Access Compliance Report

Public Rights-of-Way

(Curb Ramps)

Intersection ID: 48713	Main Street: ROLLING_CREEK_CT	Cross Street: KILCULLEN_DR	Location: S
ADA ID: 19D1DC407E93	Ramp Type: Perp	Initial Pass/Fail: Fail	Overall Compliance: No
Severity Score: 13.75			
Codes/Mitigation Info/Possible Solution		Field Measurements/Component Compliance

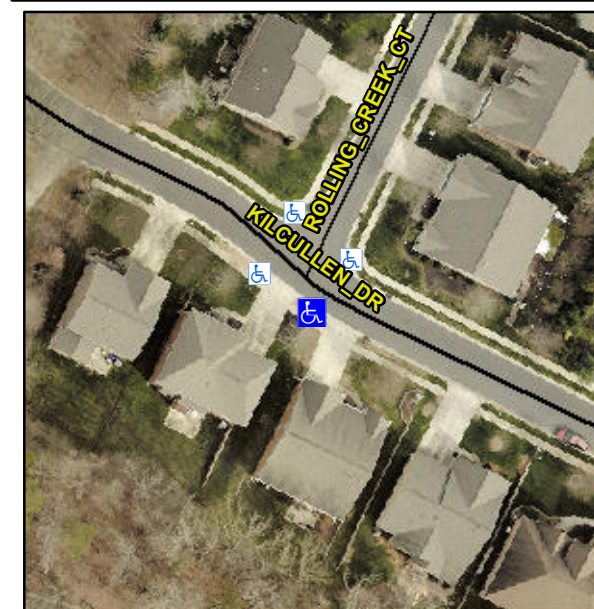
Possible Solutions:

Remove & Replace Entire Ramp.

PROW/ADA:

R304.2.2, R304.5.3

Compliance	Description	Data	Compliance	Description	Data
N/A	Ramp Length (in)	47.0	No	Ramp Slope (%)	8.8
Yes	Ramp Width (in)	48.0	No	Ramp XSlope (%)	4.0
N/A	Flare Type LT	N/A	N/A	Flare Type RT	N/A
N/A	Flare Slope LT (%)	N/A	N/A	Flare Slope RT (%)	N/A
N/A	Flare Traversable LT?	N/A	N/A	Flare Traversable RT?	N/A
N/A	Landing Length (in)	N/A	N/A	DWS Provided?	N/A
N/A	Landing Width (in)	N/A	N/A	DWS Contrast?	N/A
N/A	Landing Slope (%)	N/A	N/A	DWS Length (in)	N/A
N/A	Landing X Slope (%)	N/A	N/A	DWS Full Width?	N/A
N/A	Landing Curb? (Y/N)	N/A	N/A	DWS Offset (in)	N/A
N/A	Shared Landing?	N/A			
N/A	Gutter Ponding?	N/A	N/A	Gutter Slope (%)	N/A
N/A	Gutter Lip Ht (in)	N/A	N/A	Gutter X Slope (%)	N/A
N/A	Painted X Walk1?	No	N/A	Painted X Walk2?	N/A
	X Walk 1 Direction	To NE		X Walk 2 Direction	N/A
N/A	X Walk 1 Width (in)	N/A	N/A	X Walk 2 Width (in)	N/A
	X Walk 1 Slope (%)	2.2		X Walk 2 Slope (%)	N/A
	X Walk 1 X Slope (%)	3.3		X Walk 2 X Slope (%)	N/A
